The National Construction Code Volume One

SSDA Submission

Nepean Hospital Redevelopment - Stage 2

Date: 30 September 2021

Figure No. 11 – Rising and descending stair flights within Fire Stair 01 to be separated

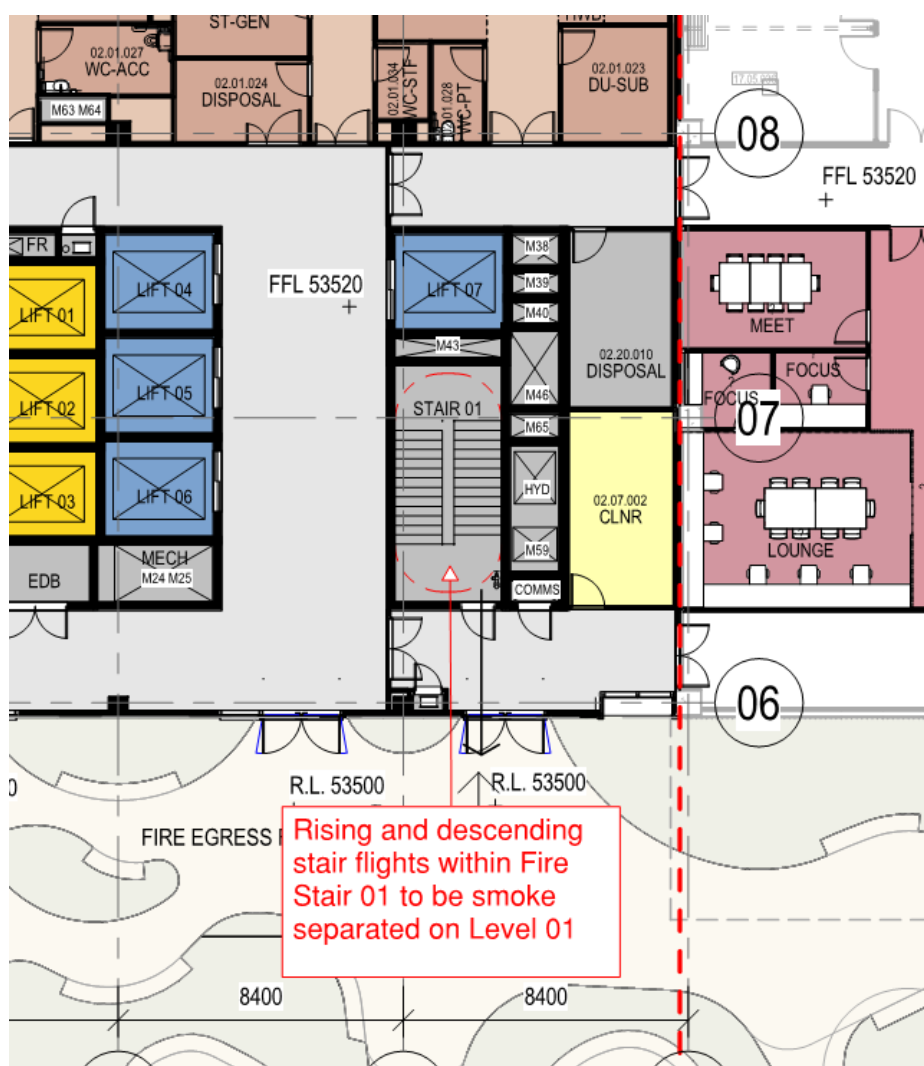
In this instance, it is noted that Fire Stair 01 contains a rising and descending stair flight, with the stairway discharging on Level 01, however the stairway descends down to Level 00.

The rising and descending stair flights will be required to be smoke separated in accordance with the Specification C2.5.

If the stairways are not to be smoke separated in accordance with Specification C2.5, then the design will be required to be assessed as part of a Fire Engineering Performance Assessment to be undertaken by Arup in order to demonstrate compliance with the nominated Performance Requirements of the BCA.

Figure No. 35 – Required provision of Emergency Lifts

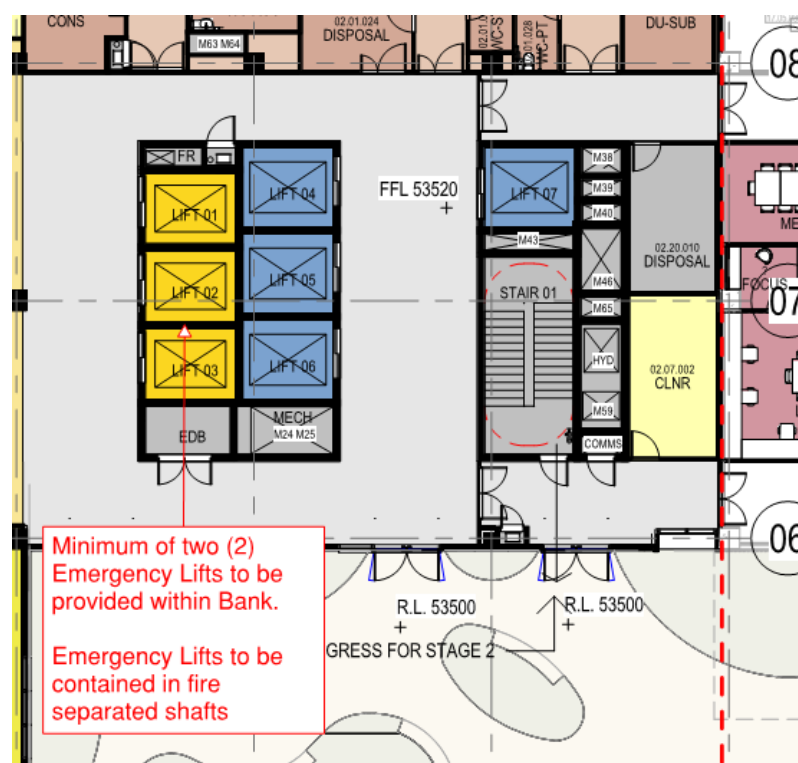
Due to the fact that the lifts are contained within the same bank, they will be required to be contained within separate fire rated shafts.
